# UNITED STATES PATENT AND TRADEMARK OFFICE

APPLICATION NO.	FILING DATE	FIRST NAMED INVENTOR	ATTORNEY DOCKET NO.	CONFIRMATION NO.
10/801,430	03/16/2004	John Kim	81095567	3073

# Office Action Summary

### **DETAILED ACTION**

**EXAMINERS FIGURE 1**

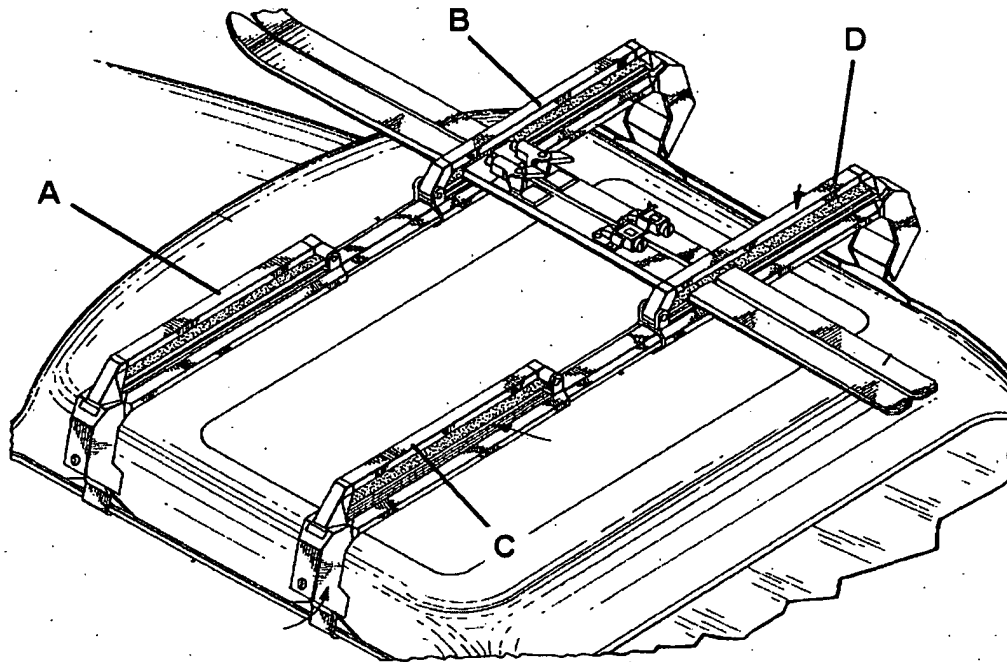
Claim 1 is rejected under 35 U.S.C. 102(b) as being anticipated by Olliges (US 4,728,019). Olliges discloses a roof rack apparatus comprising: (see Examiners Figure 1 below) first and second laterally disposed front side rail members A/B; first and second laterally disposed rear side rail members C/D, each side rail member being pivotally movable independently of each other; multiple storage surfaces defined at lead line 136 under each side rail; and wherein each side rail includes a hinge bar 128 to permit pivotal movement between a raised basket forming position and a lowered collapsed position.
